# ZAYO'S PRINEVILLE TO RENO PROJECT

## CPUC MINOR PROJECT REFINEMENT FORM

<b>Date Requested:</b> 15 Oct 2024	<b>Report No.:</b> 8
<b>Date Approved:</b> 11/6/24	<b>Approval Agency:</b> Caltrans, in addition to CPUC
<b>Property Owner(s):</b> Caltrans (State Route 395 ROW)	<b>Location/Milepost:</b> PM L-102.70 to L-102.95 (S to N)
<b>Land Use/Vegetative Cover:</b> Ruderal (maintained highway shoulder near edge of pavement)	<b>Sensitive Resources:</b> Cultural resources present. No other sensitive resources present. (See project webmap.)

RFI_0292,293,294_MP_L_AM53to54	
<b>AM - JUMPER RIDGE RD TO MILFORD</b>	
SCALE: 1"=100'	SHEET NO.: 53 OF 84
JOB NUMBER: UPR	
DRAWN BY: WP	DATE: 10/3/24

**VIEWPORT - 53**

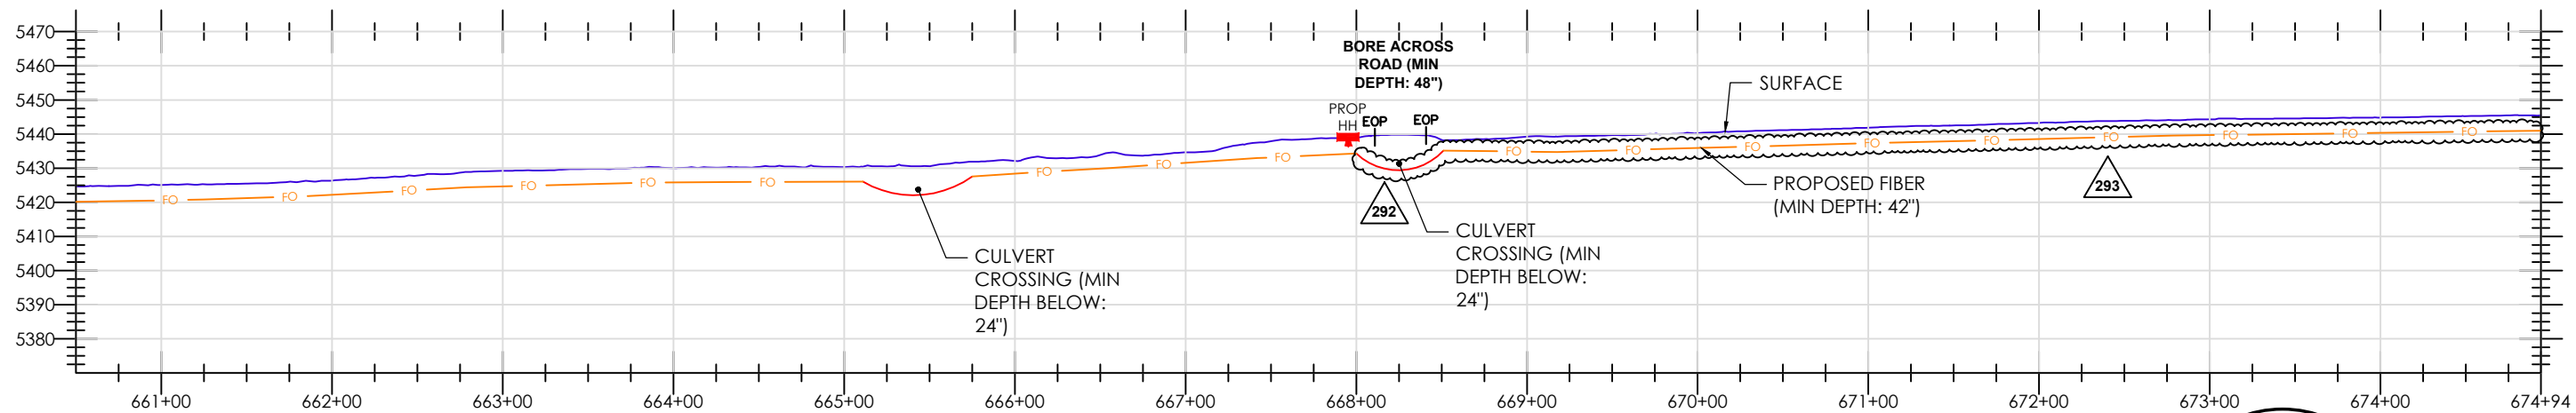
RFI NO. 0292 NEW BORE CROSSING TO WEST 10 FEET FROM EOP ON WEST SIDE STA 668+00	10/04/2024
RFI NO. 0293 SHIFT R/L TO 10 FEET OFFSET FROM WEST SIDE STA 668+00 TO STA 681+30	10/04/2024

**VIEWPORT - 54**

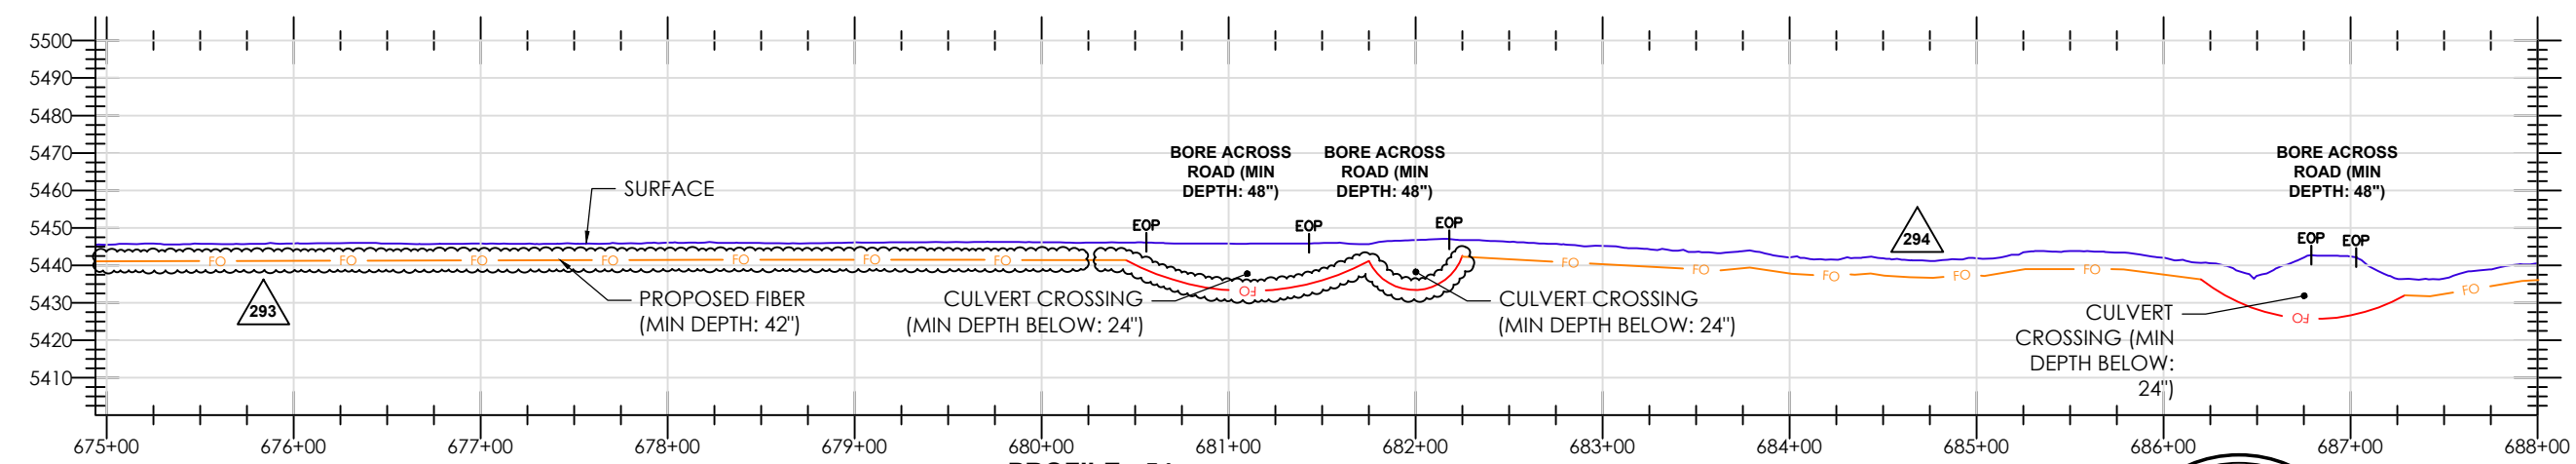
RFI NO. 0293 SHIFT R/L TO 10 FEET OFFSET FROM WEST SIDE STA 668+00 TO STA 681+30	10/04/2024
RFI NO. 0294 NEW BORE TO CROSS DRIVEWAY & BACK TO EAST SIDE STA 680+00 TO 681+30	10/04/2024
